UN/SCETDG/50/INF.7/Add.3
UN/SCEGHS/32/INF.5/Add.3

**Revision of the Manual of Tests and Criteria:
Part II: (Sections 20 to 28)**

**Transmitted by the Chairman of the Working Group on Explosives on
behalf of the Working Group**

**CLASSIFICATION PROCEDURES,
TEST METHODS AND CRITERIA
RELATING TO
SELF-REACTIVE SUBSTANCES ~~OF~~
~~DIVISION 4.1~~
AND ORGANIC PEROXIDES ~~OF~~
~~DIVISION 5.2~~**

Figure 20.1-(a): FLOW CHART SCHEME FOR SELF-REACTIVE SUBSTANCES AND ORGANIC PEROXIDES

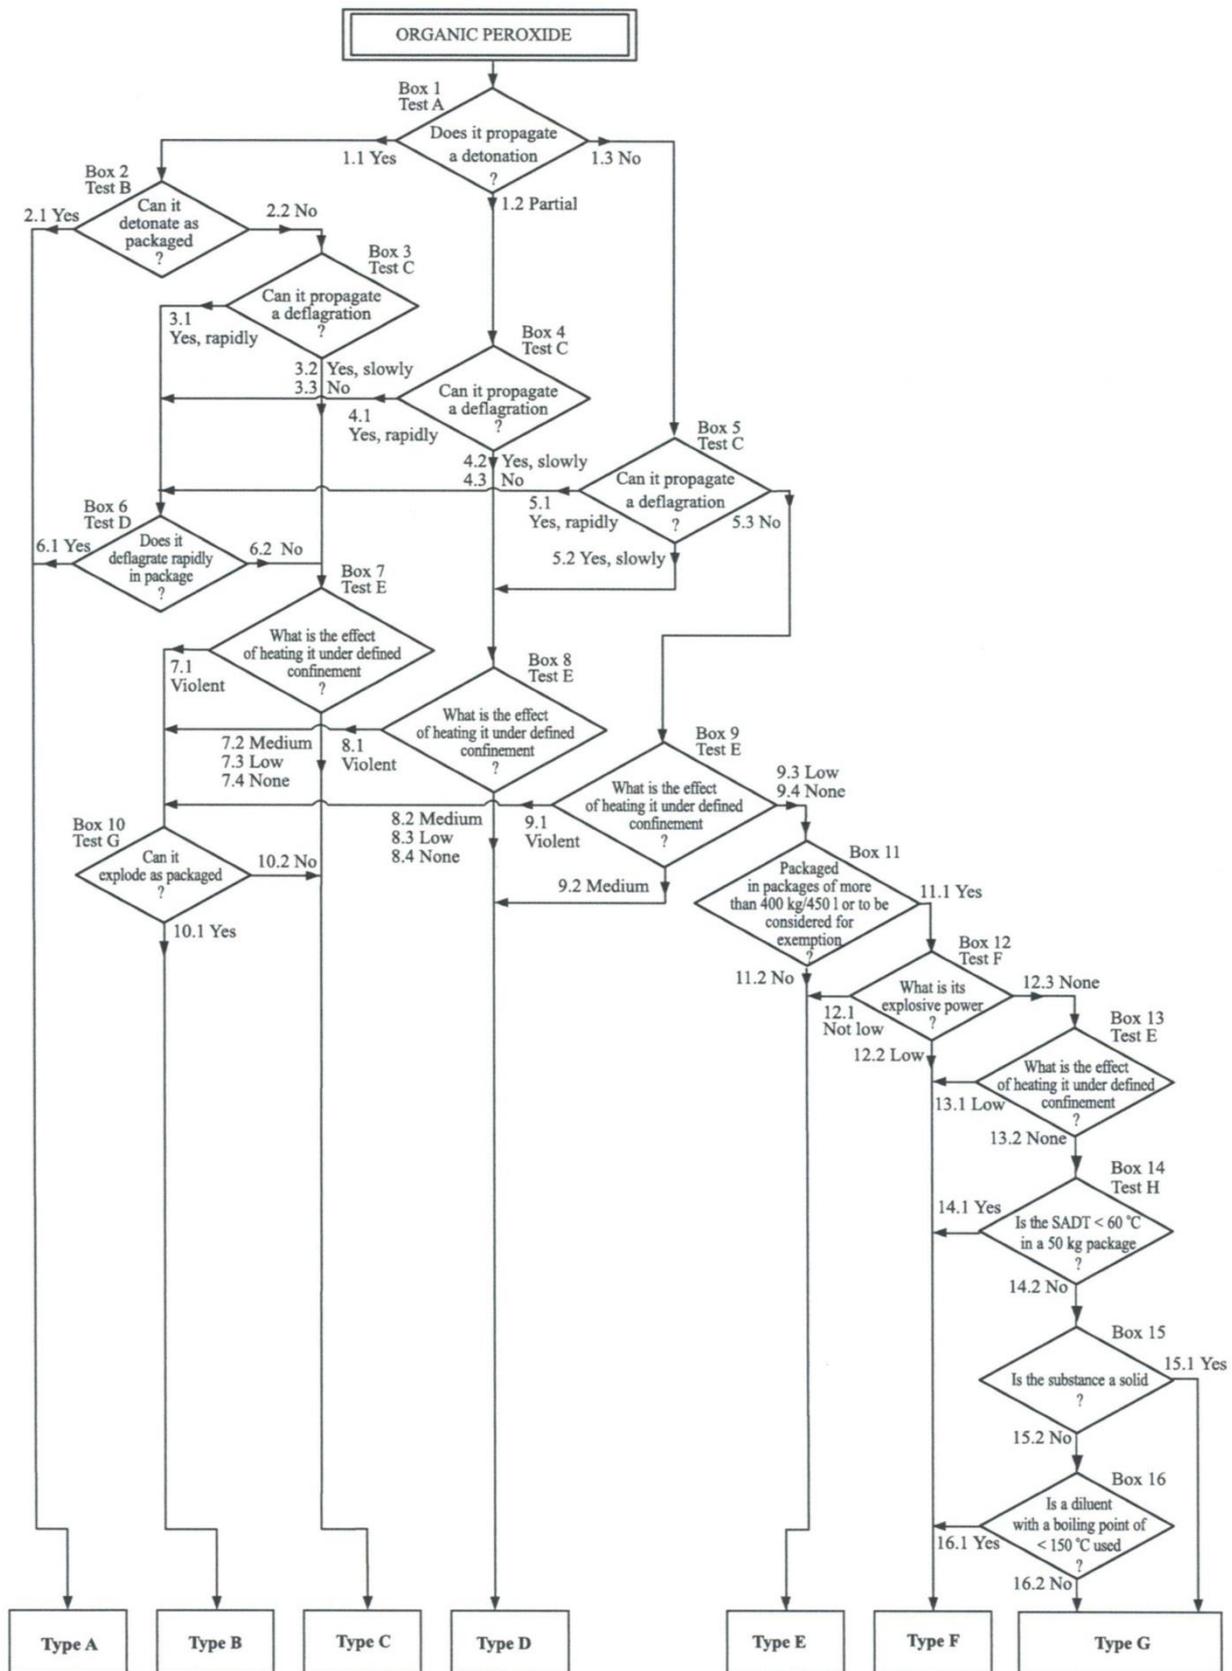
~~Figure 20.1 (b): FLOW CHART SCHEME FOR SELF-REACTIVE SUBSTANCES AND ORGANIC PEROXIDES (cont'd)~~

Figure 20.3: CLASSIFICATION OF TERT-BUTYL PEROXYBENZOATE

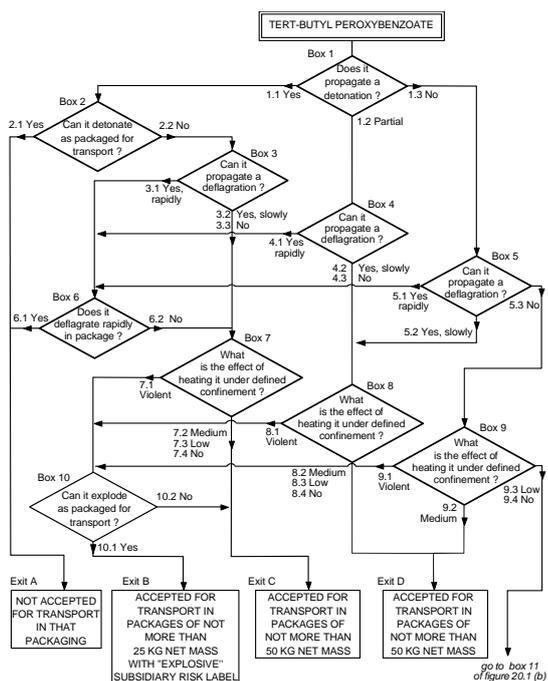
In box 2 and 10: remove the words “for transport”
In box 6 replace “in package” by “as packaged”
Replace “Exit A” to “Exit D” with “Type A” to “Type D”
Remove boxes under the “Exits”
Remove the words “of figure 20.1 (b)” to the reference “go to box 11”

Note by the secretariat: The Sub-Committee is invited to consider whether the proposed reference “go to box 11”, should be amended to read “go to box 11 of figure 20.1” as there is no box 11 in figure 20.3.
